REMARKS

B. Drawings

During the course of Applicant's review of the specification and drawings in preparation for responding to the Official Action, Applicant discovered the informalities identified below in the drawings. Accordingly, applicant requests permission to amend the drawings in the following manners:

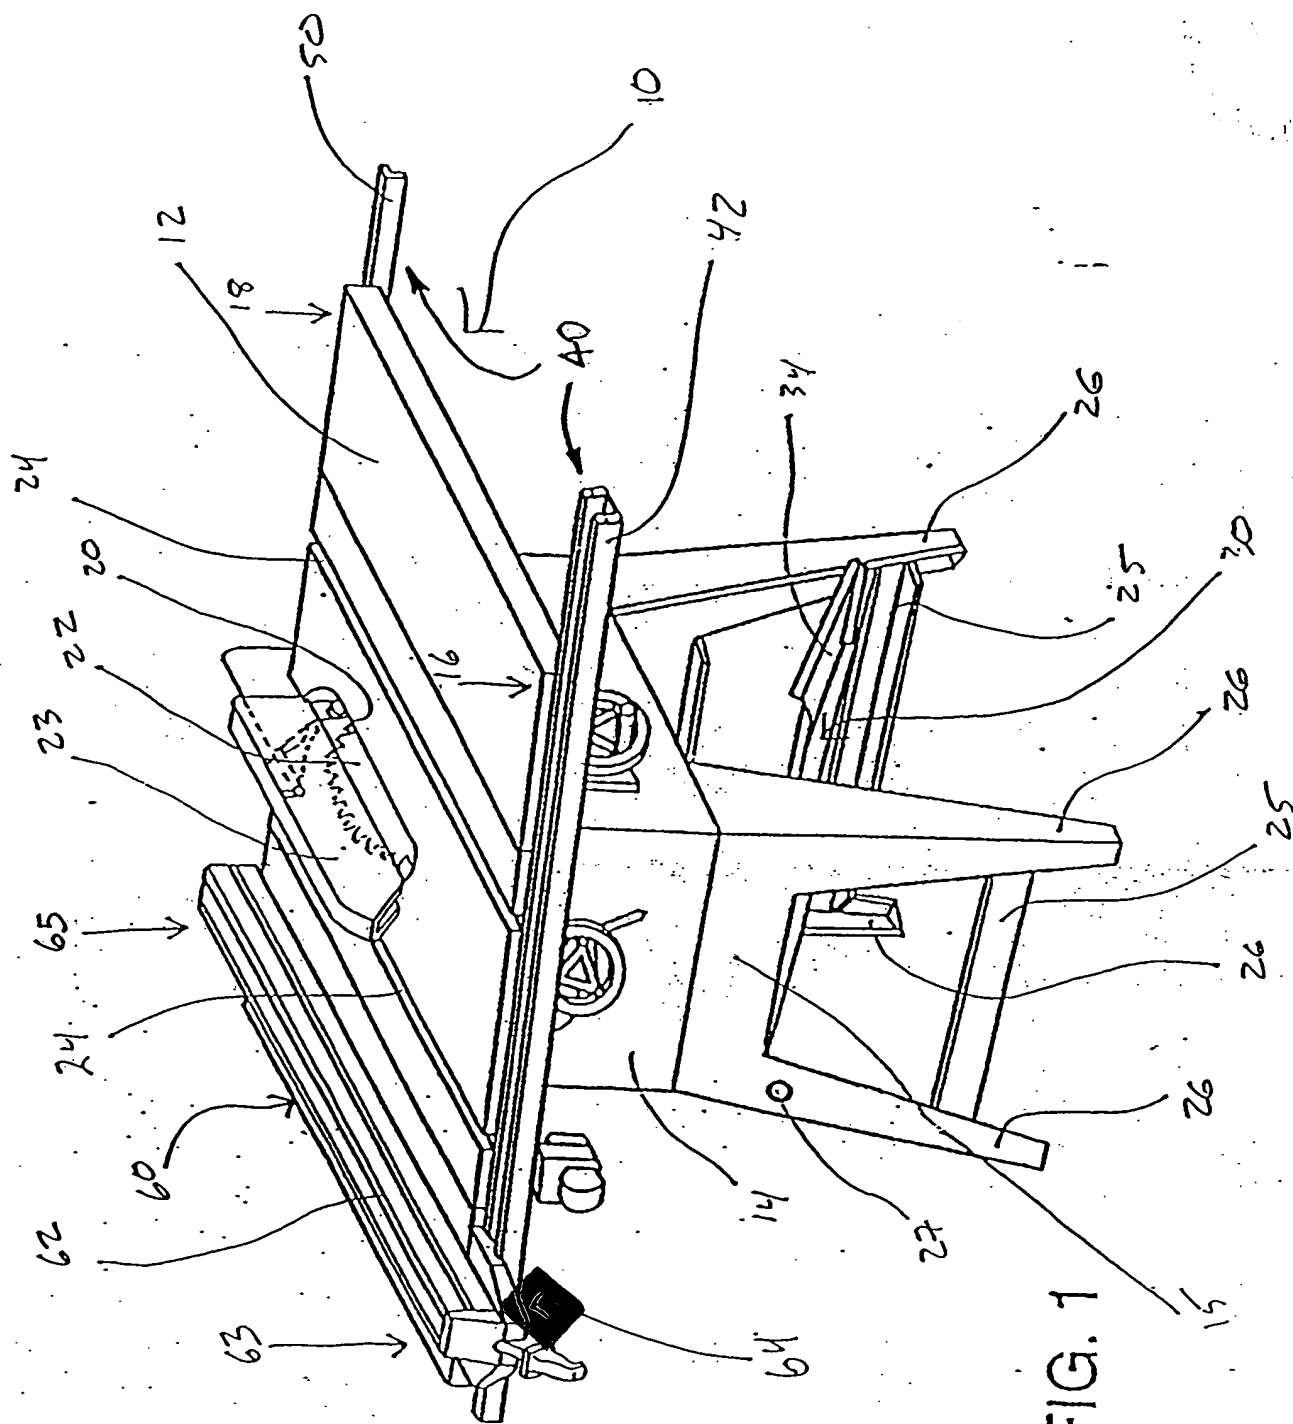
Figure 1: Reference number "64" lead line amended to terminate with an arrow.

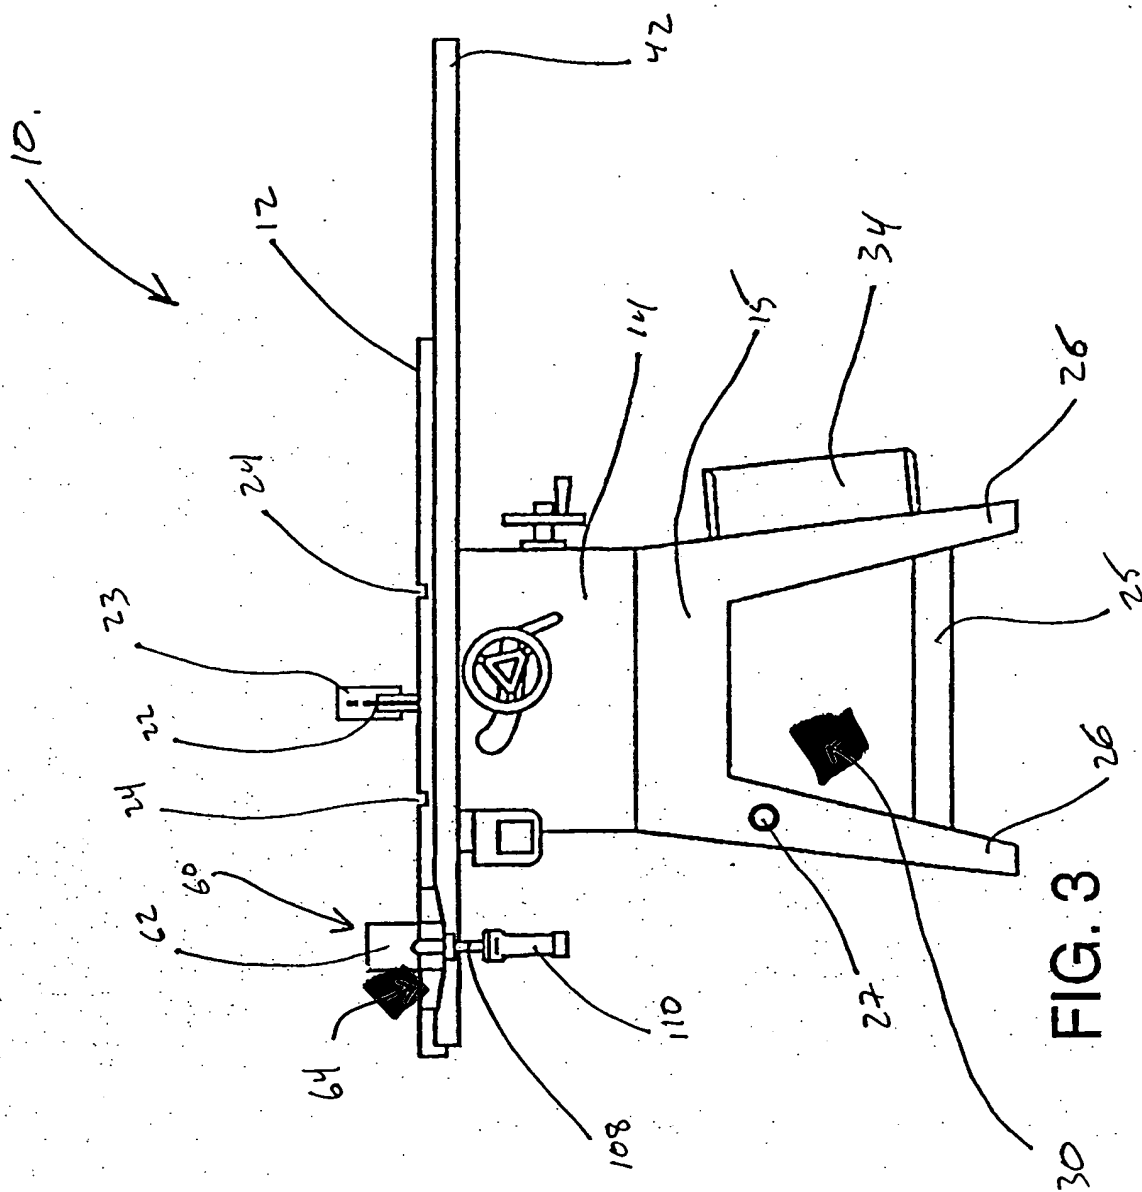
Figure 2: Reference number "64" lead line amended to terminate with an arrow.

Reference number "60" lead line amended to terminate with an arrow.

Reference number "30" lead line amended to terminate with an arrow and redirected to point to proper element.

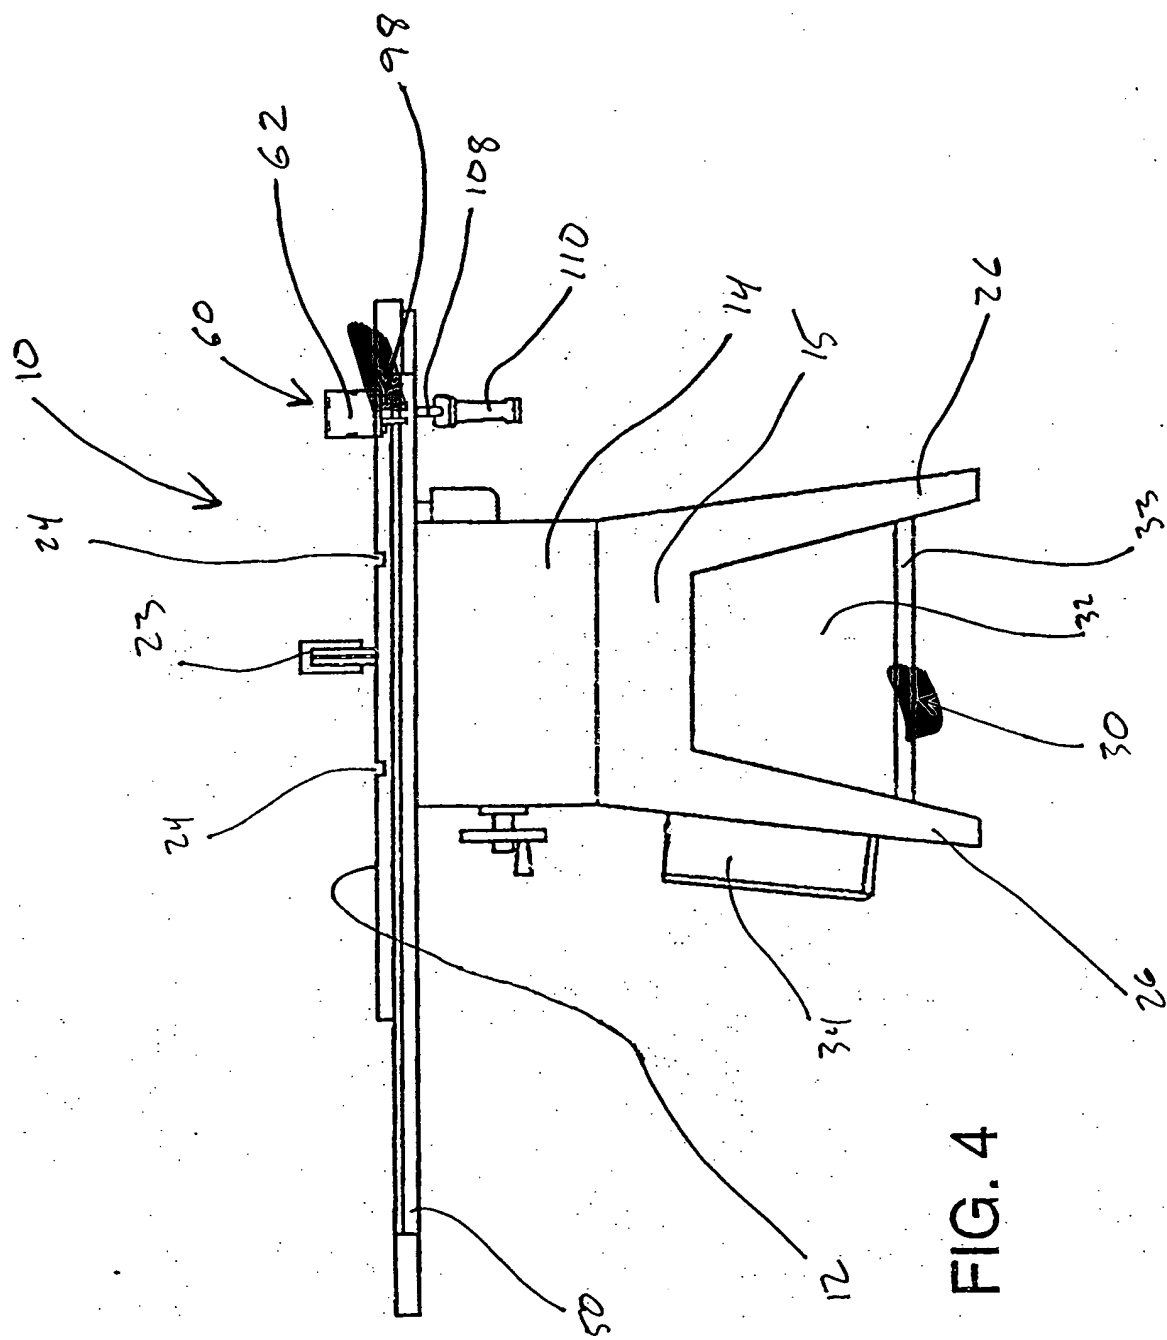
Figure 3: Reference number "64" lead line amended to terminate with an arrow.

Reference number "30" lead line amended to terminate with an arrow.

FIG. 5

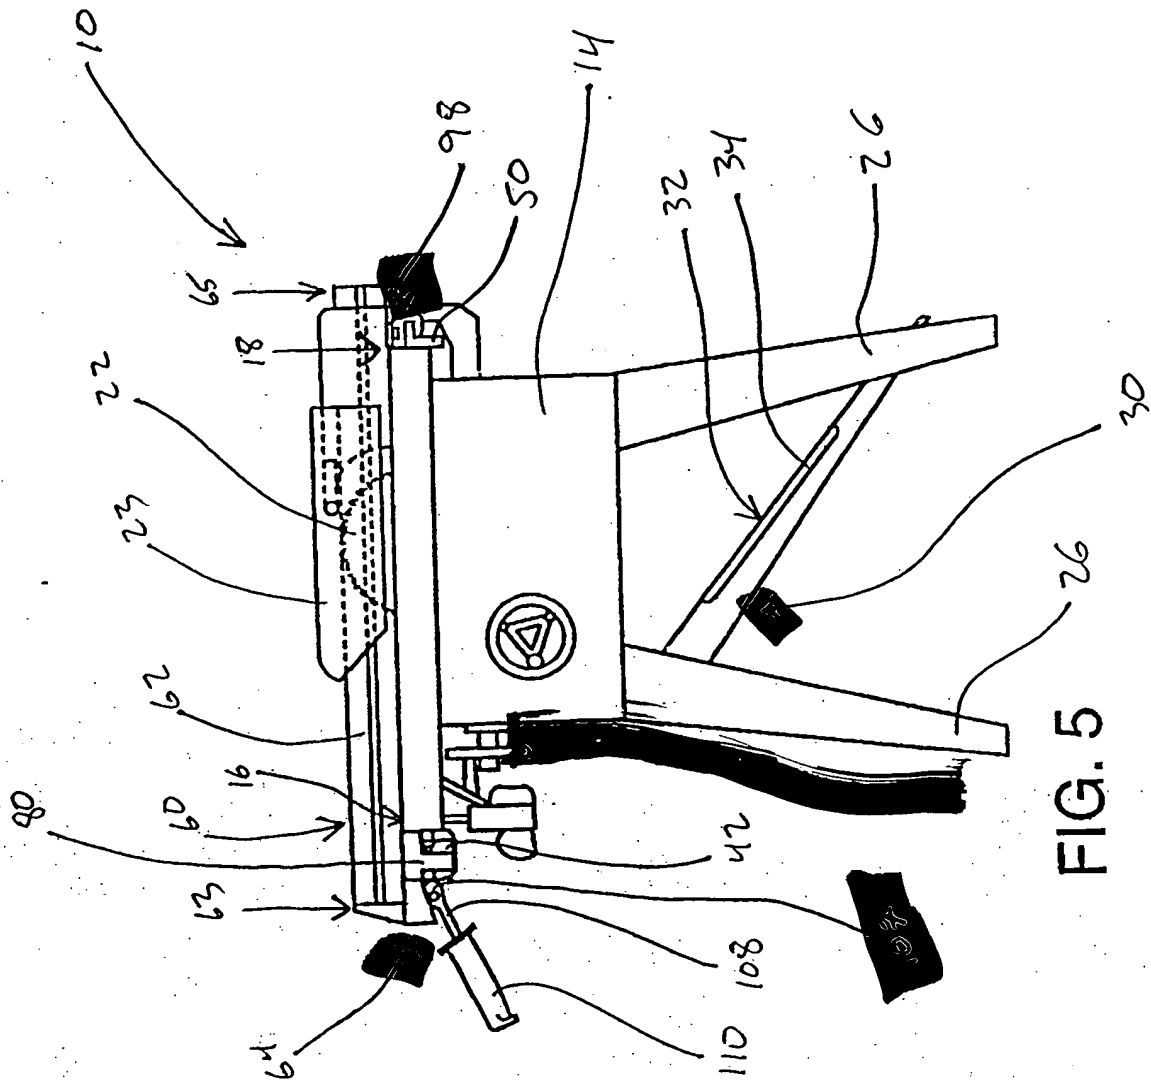
Figure 5: Reference number "98" lead line amended to terminate with an arrow.

Reference number "30" lead line amended to terminate with an arrow.

Reference number "12" and reference number "12" lead line deleted.

Reference number "105" replaced with reference number "107" to properly show the element.

Reference number "64" lead line amended to terminate with an arrow.

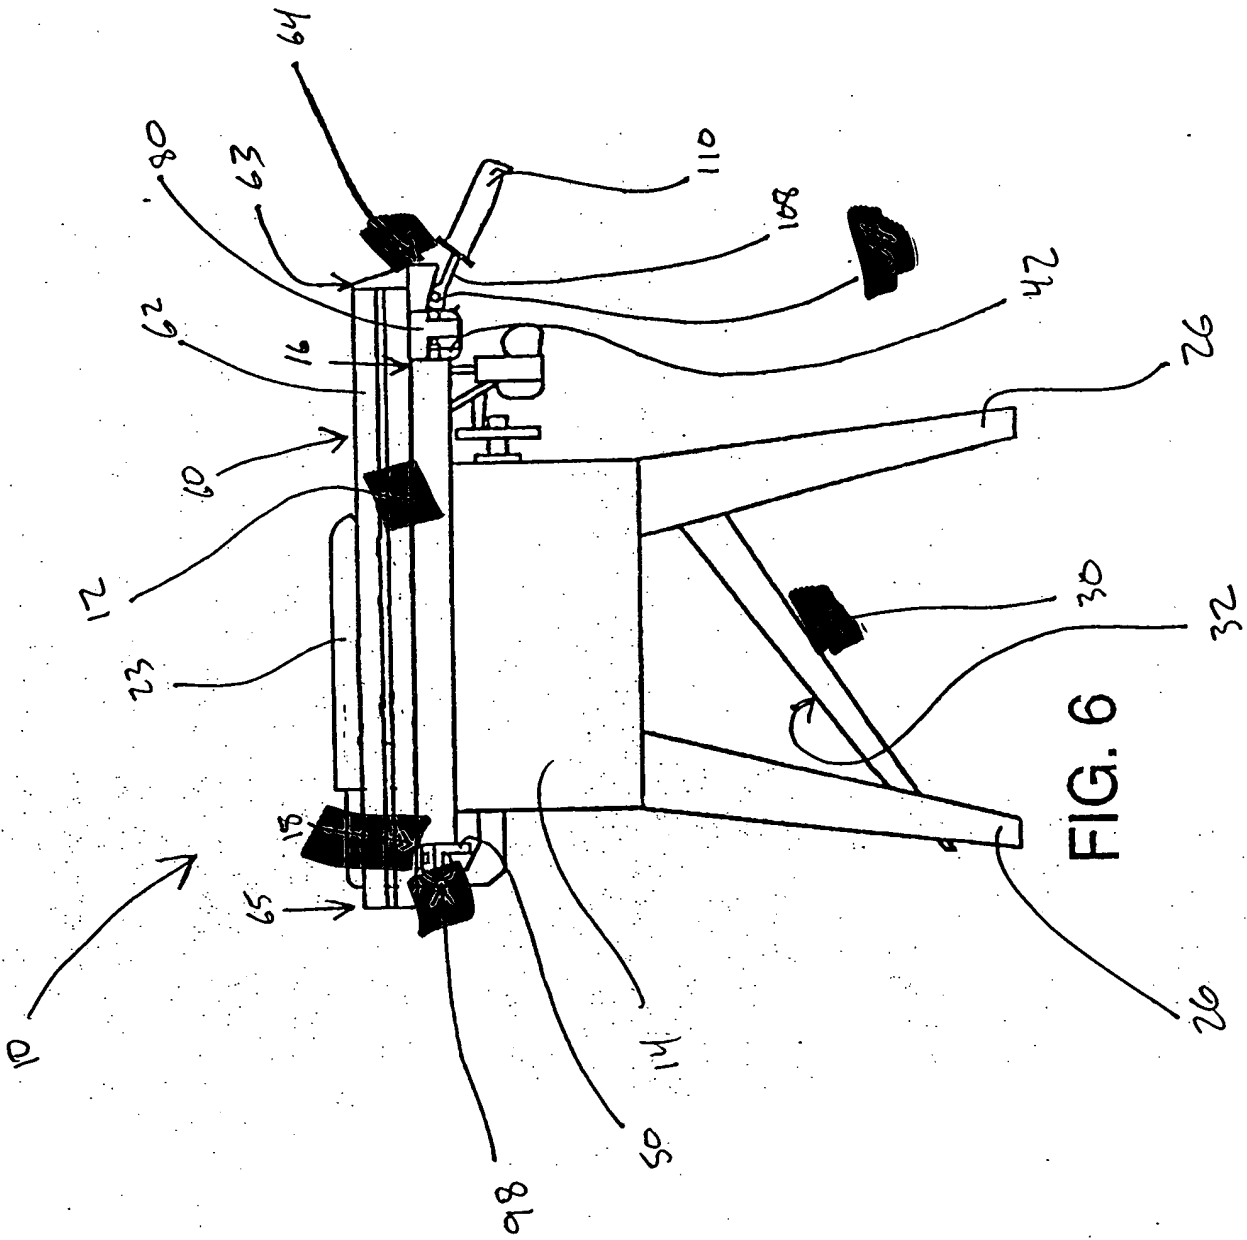
Figure 6: Reference number "98" lead line amended to terminate with an arrow.

Reference number "18" lead line redirected to point to proper element surface.

Reference number "12" lead line redirected to point to proper element surface.

Reference number "64" lead line amended to terminate with an arrow.

Reference number "105" replaced with reference number "107" to properly show the element.

Reference number "30" lead line amended to terminate with an arrow.

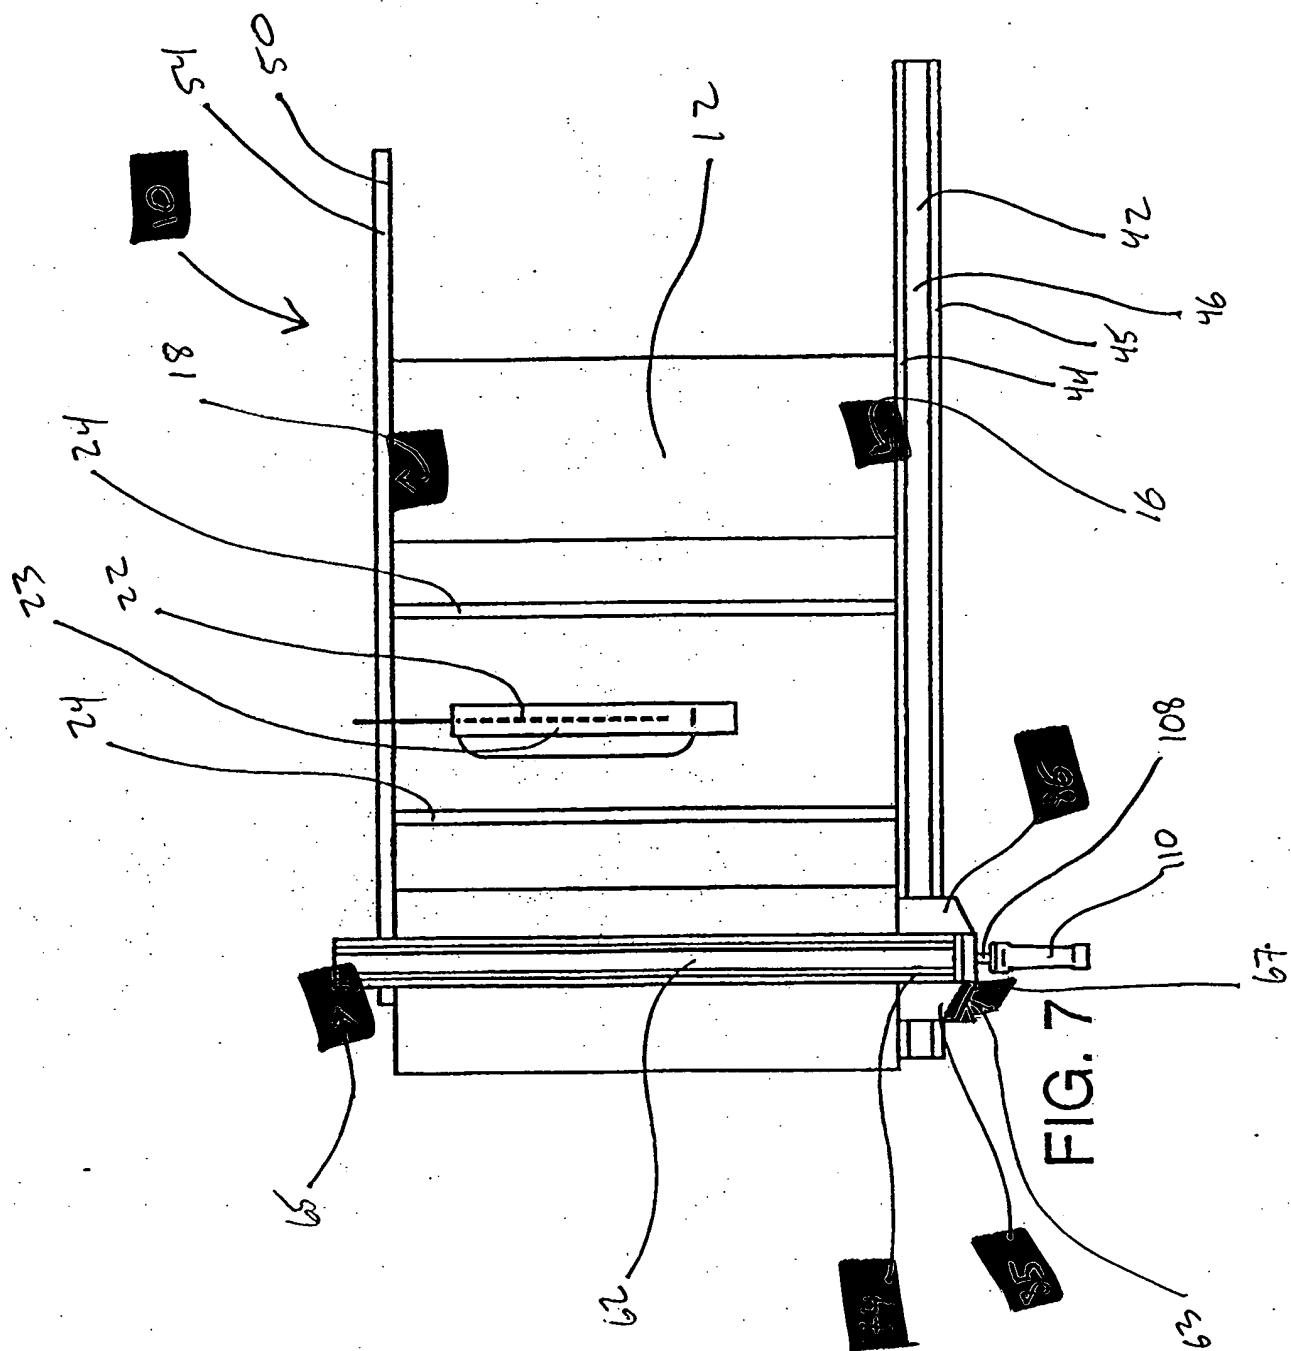
Figure 7: Reference number "65" lead line amended to terminate with an arrow.

Reference number "18" lead line amended to terminate with an arrow.

Reference number "110" replaced with reference number "10" to properly show the element.

Reference number "16" lead line amended to terminate with an arrow.

Reference number "85" replaced with reference number "86" to properly show the element.

Reference number "86" replaced with reference number "85" to properly show the element.

Reference number "67" lead line amended to terminate without an arrow and redirected to point to proper element surface.

Reference number "63" replaced with reference number "74" to properly show the element.

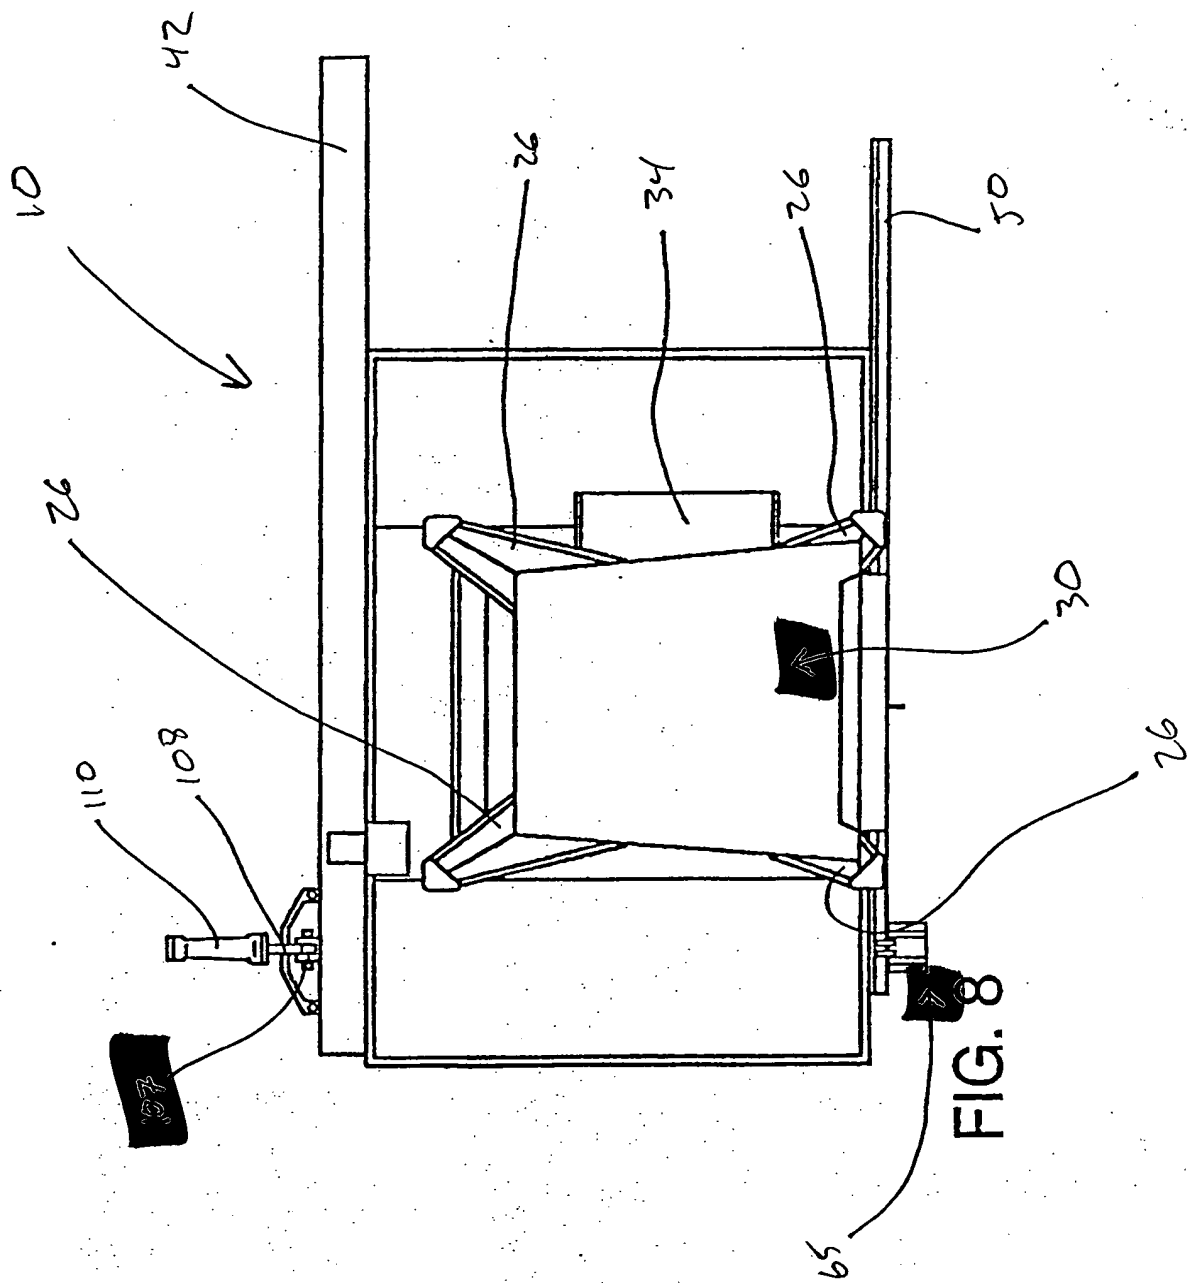
Figure 8: Reference number "105" replaced with reference number "107" to properly show the element.

Reference number "65" lead line amended to terminate with an arrow.

Reference number "30" lead line amended to terminate with an arrow.
